OSN 47-09-9

SUBJECT: MAIN ROTOR HUB INBOARD THRUST DUPLEX BEARING

047-120-417-XXX, IDENTIFICATION OF THRUST SIDE.

Typical Tandem Installation

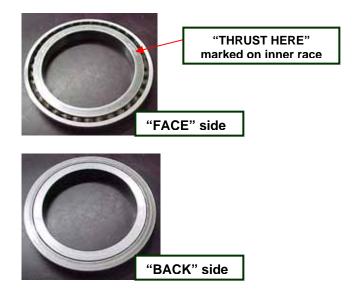
Bell helicopter has received an unconfirmed report of main rotor hub inboard thrust duplex bearing premature degradation due to improper installation. At this stage of the investigation, it is suspected that the "THRUST HERE" marking on the "Face" side of the bearing may cause confusion and lead to improper installation of the bearing.

This Operation Safety Notice (OSN) is issued to advise Owners/Operators of this potential situation and clarify the correct installation of the main rotor hub inboard thrust duplex bearing. For correct installation, refer to the applicable Maintenance & Overhaul Manual and the pictures/figure below. This installation is commonly named "TANDEM DUPLEX".
